# IPC Project Briefing No. 2

## United Wambo Open Cut Coal Mine Project

# IPC Review

## Response to Recommendations

## R31 – Voids: Groundwater Recovery Level

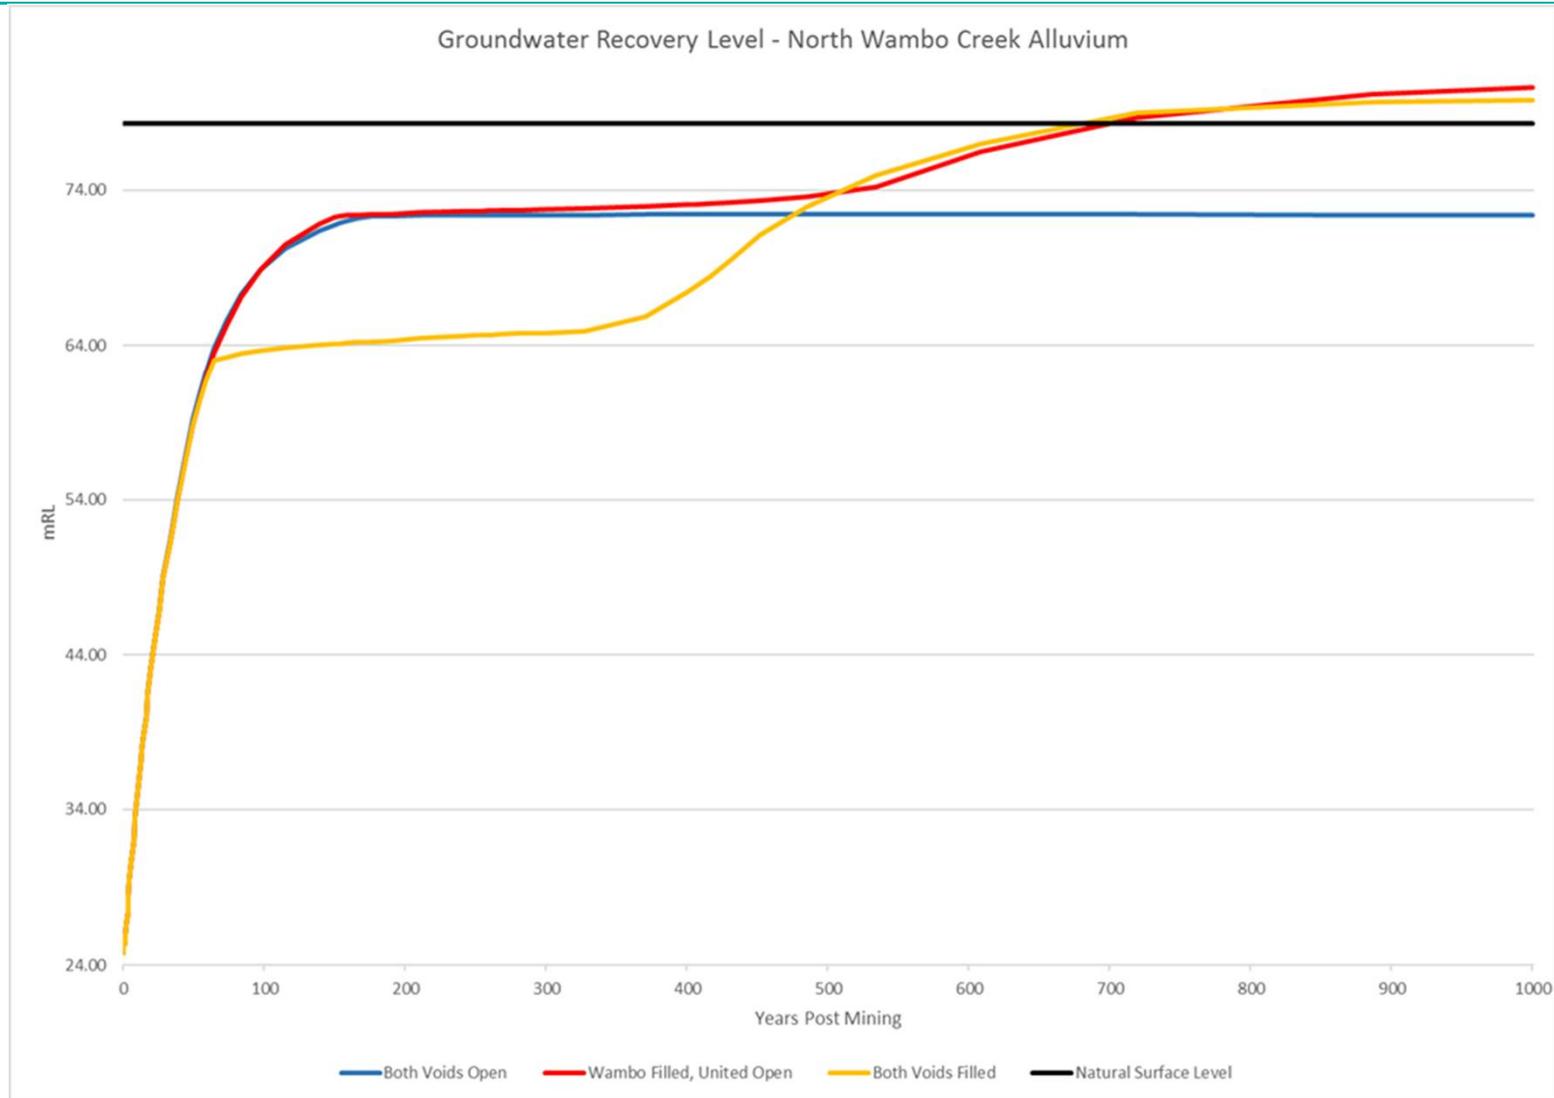
## R31 – Voids: Groundwater Recovery Level

The section indicates that water within the spoil adjacent to North Wambo Creek is likely to flow into the alluvium and/or express on the surface
